**FINDINGS AND RECOMMENDATION  
OFFICE OF PLANNING AND ZONING  
ANNE ARUNDEL COUNTY, MARYLAND**

**APPLICANT:** Thomas and Katie Swope

**CASE NUMBER:** 2023-0111-V

The applicants are requesting a variance to allow a dwelling addition (screened porch) with new lot coverage nearer to the shoreline than the closest facade of the existing principal structure and that does not comply with the designated location of a principal structure on a waterfront lot on property located at 1910 Cedar Road in Pasadena.

PROPOSED CONDITIONS PLAN  
SCALE: 1" = 20'

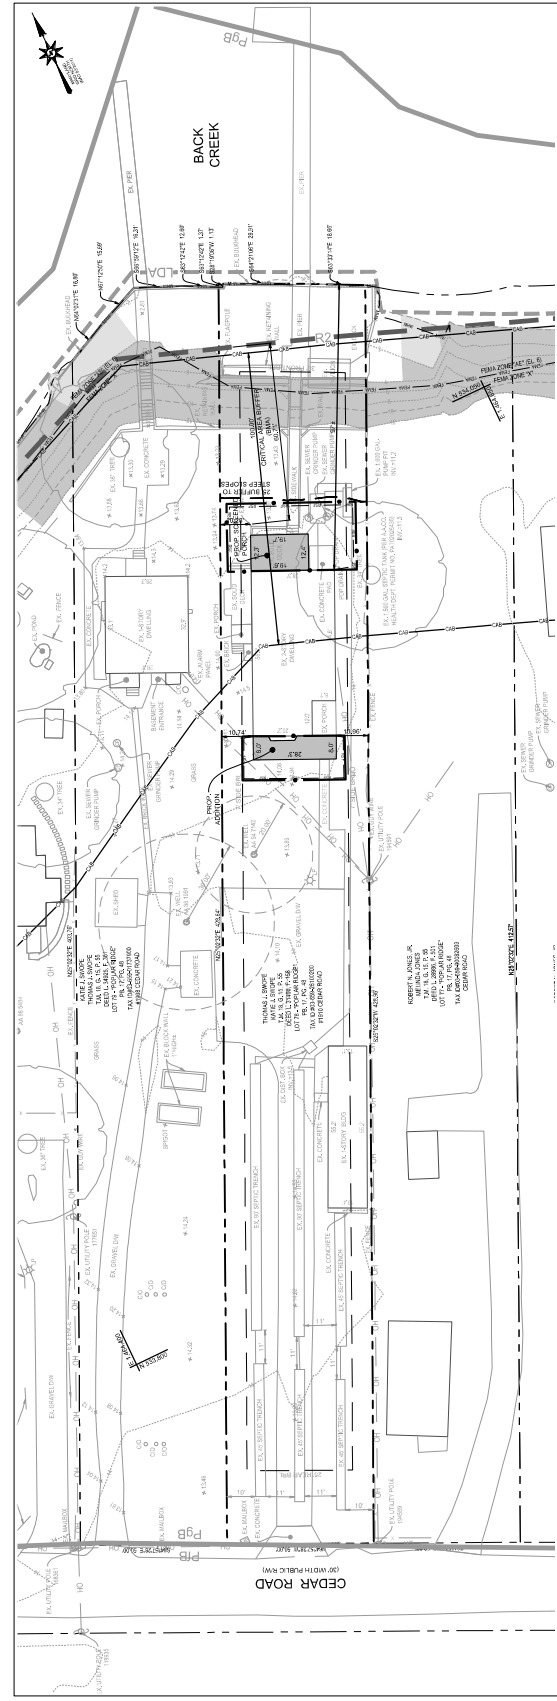
The **Critical Area Commission** commented that, provided that the proposed porch will be constructed over the existing deck and not expanded, appropriate mitigation is required. The Commission advised that they would not support an expansion of the existing footprint shoreward of the existing deck.

The **Development Division (Critical Area Team)** has no objection to the construction of a screen room over the existing deck with no expansion.

2. **2023-0111-V; Swope (AA 227-23):** Provided that the proposed porch will be constructed over the existing deck and not expanded, appropriate mitigation is required. This office would not support an expansion of the existing footprint shoreward of the existing deck.

<sup>1</sup> The letter of explanation describes the proposed porch as projecting four feet beyond the existing deck; however, based on the applicants' site plan and confirmation from the applicants' engineer, this statement is erroneous. The proposed porch would be located within the same footprint as the existing deck.
